Appendix A

Consultation Material

A.1 – Emails and Meeting Minutes

CLIENT	TOWN OF SHELBURNE
PROJECT	PUMPING TEST AND MONITORING RESULTS OF PRODUCTION WELLS PW7/PW8
DRAWING TITLE	TOPOGRAPHY AND DRAINAGE (GRCA)

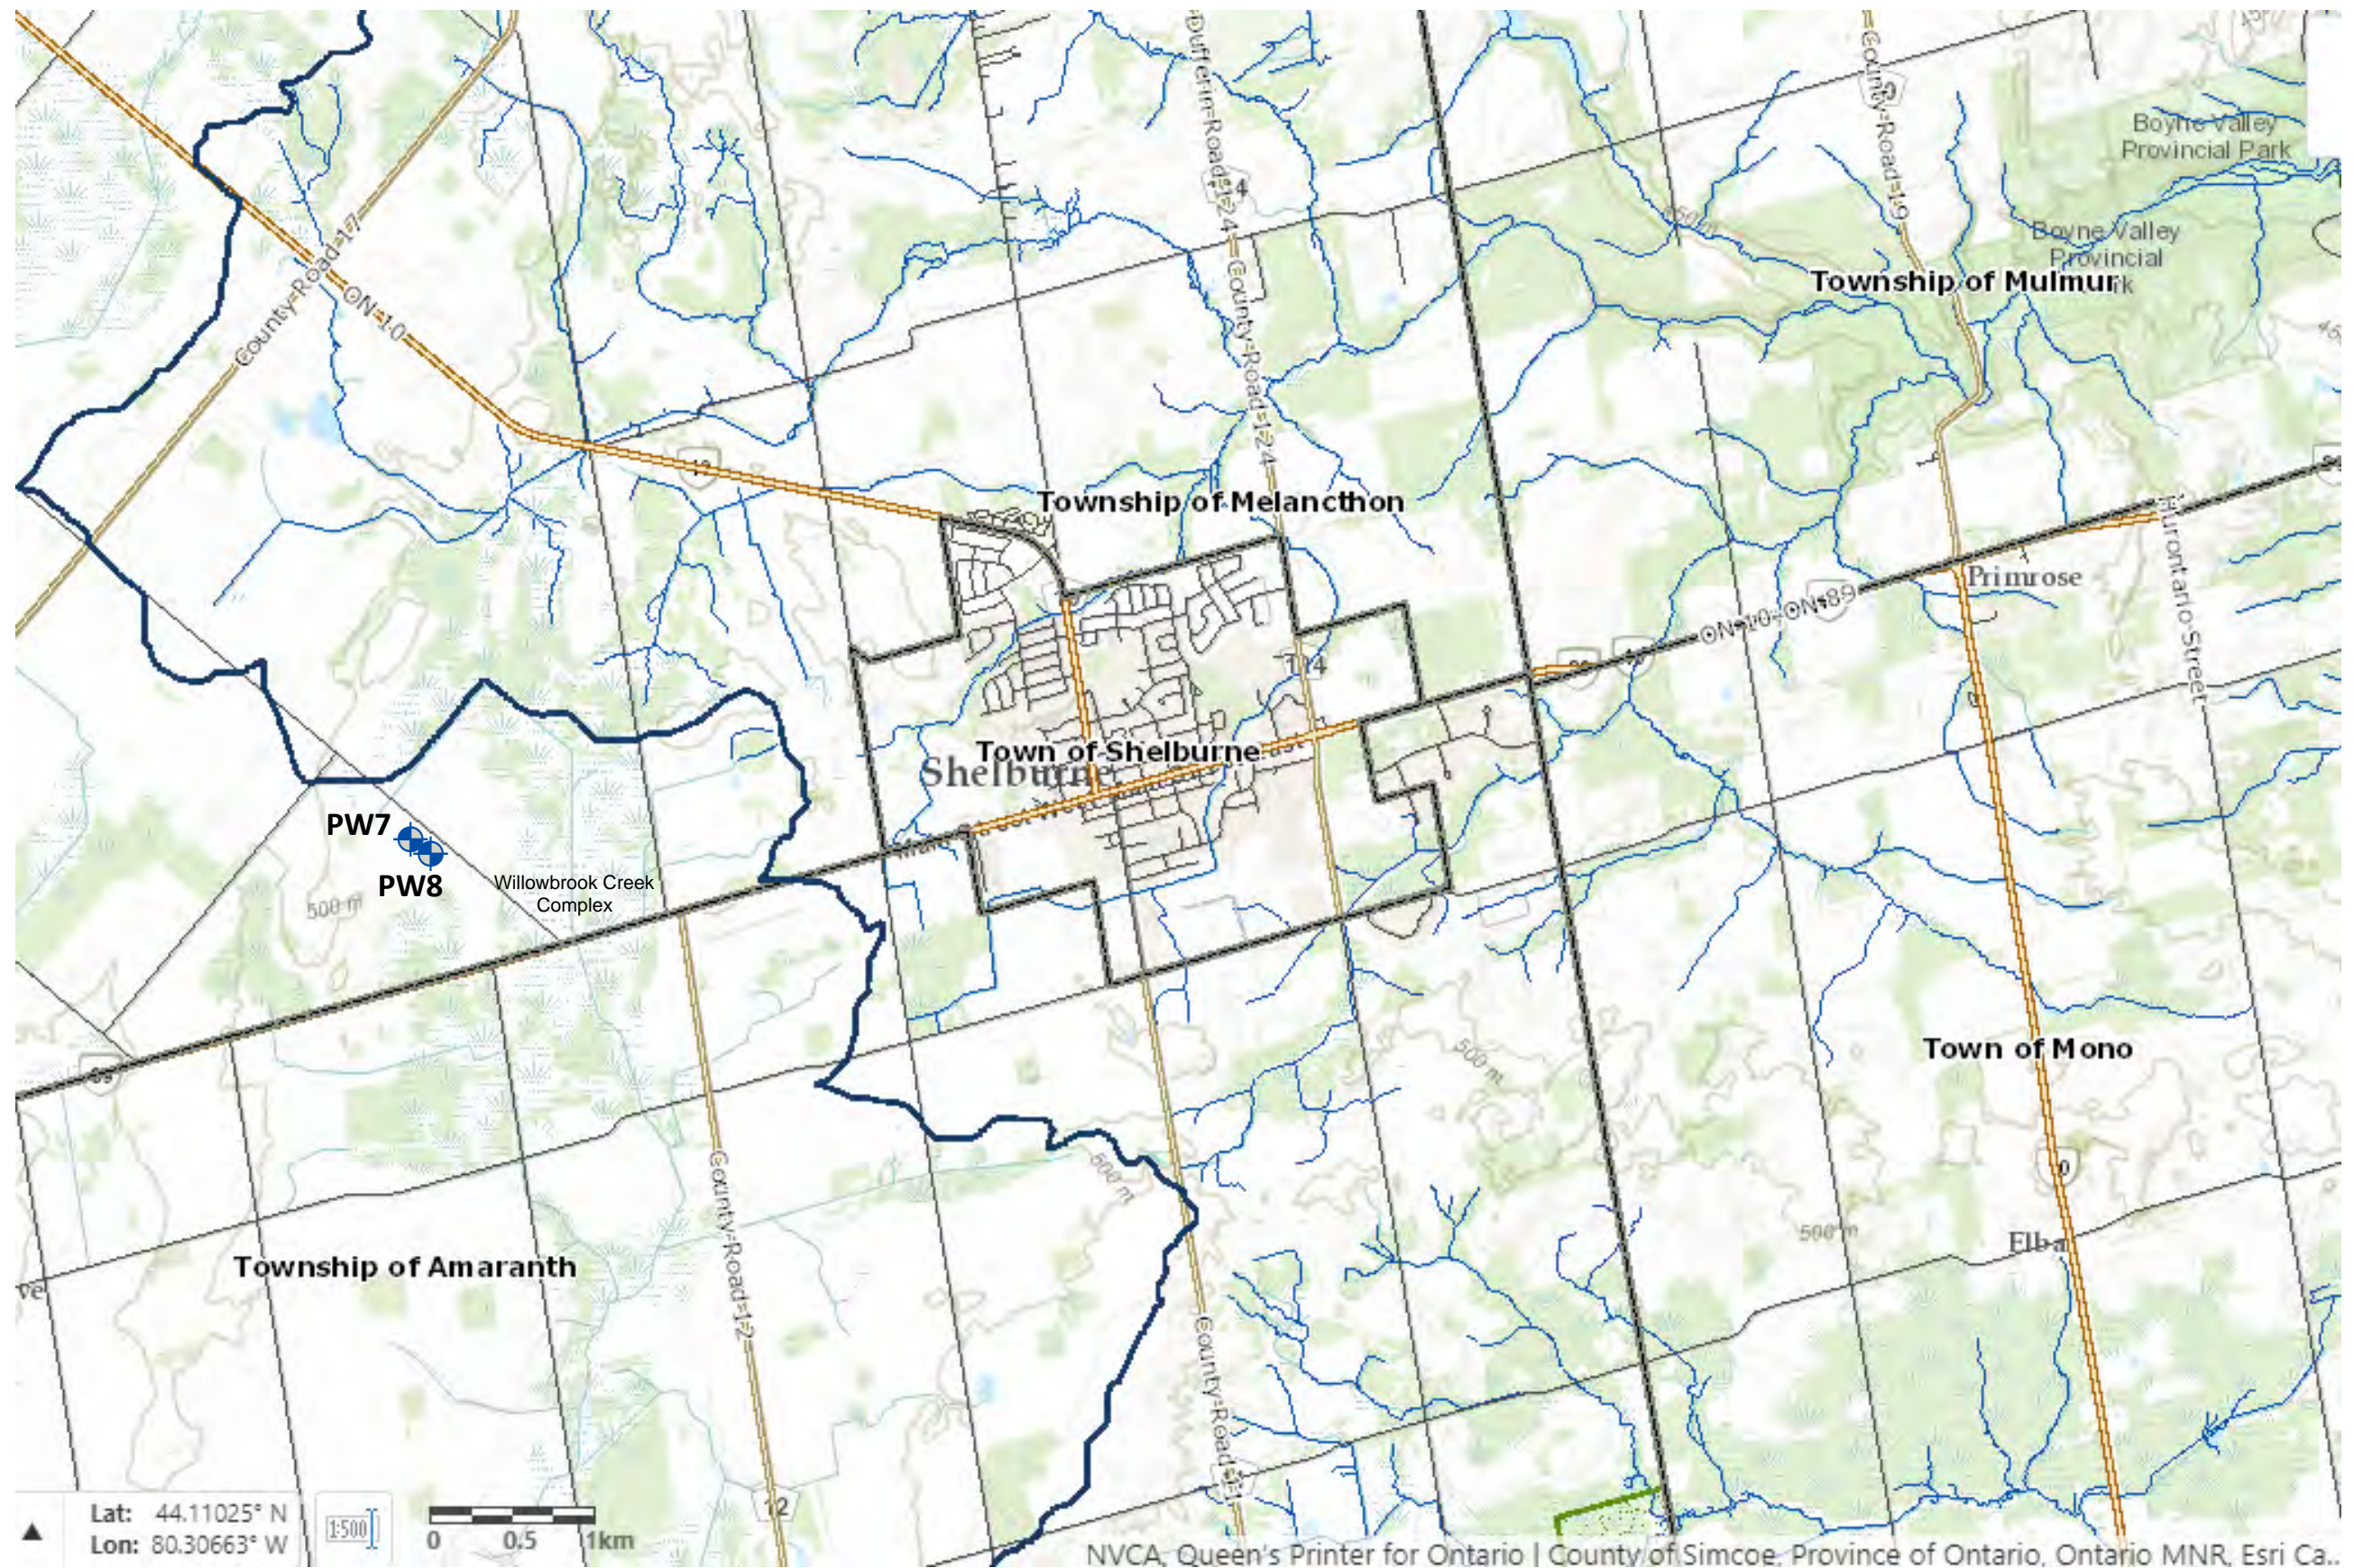
- *Pumping Test and Monitoring Results of Production Wells PW7 and PW8 Report, dated Nov. 2023*
 - Figure 3 does not show site topography. Please provide an updated figure

Figure 3 does not show site topography. Please provide an updated figure

Figure 3 has been updated to reflect site topography at the Well 7/8 location.

S. BURNETT & ASSOCIATES LIMITED ENGINEERING AND ENVIRONMENTAL SERVICES 210 BROADWAY, UNIT 203 ORANGEVILLE, ONTARIO L9W 5G4 TELEPHONE: 519-941-2949 FAX: 519-941-2036		FIGURE 5	
DESIGNED BY I.C.	DRAWN BY S.L.	VERIFIED BY S.B.	PROJECT No. M17025
SCALE NTS

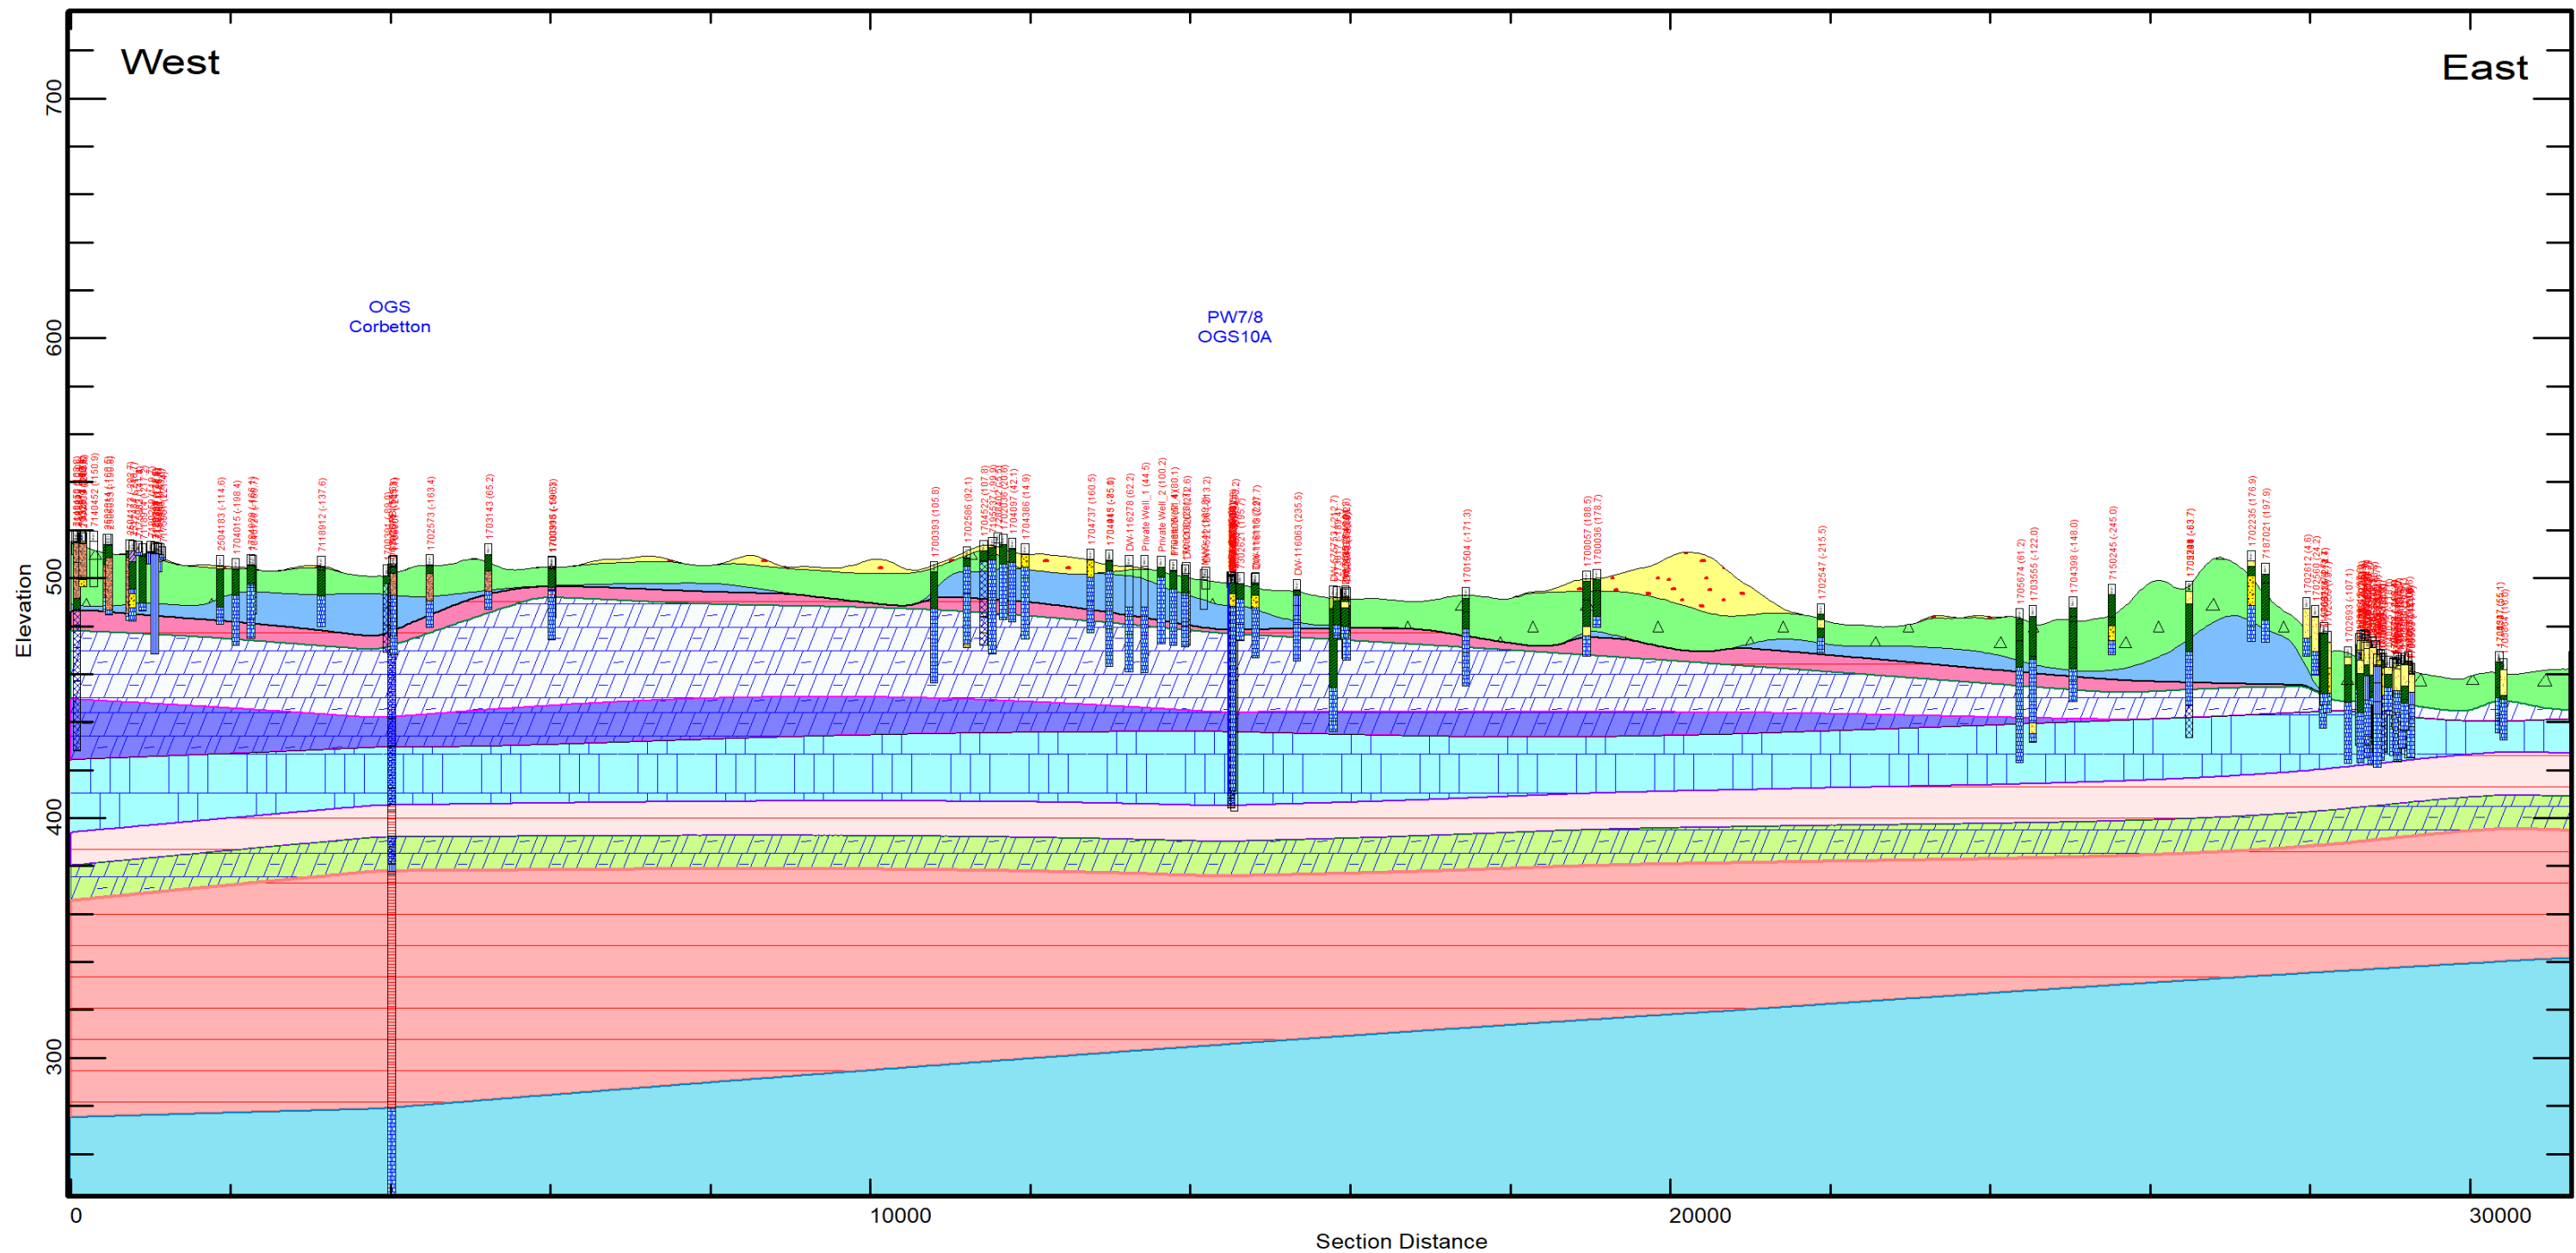
- Figures 5 and 6 do not have a legend. Please update these figures
 - Appendix C1, please provide names of wells with tag numbers A076887 and A081584. Drawing 1 shows depths not elevations. Please update this figure to show elevations.

Figure 5 has been updated to include a legend.
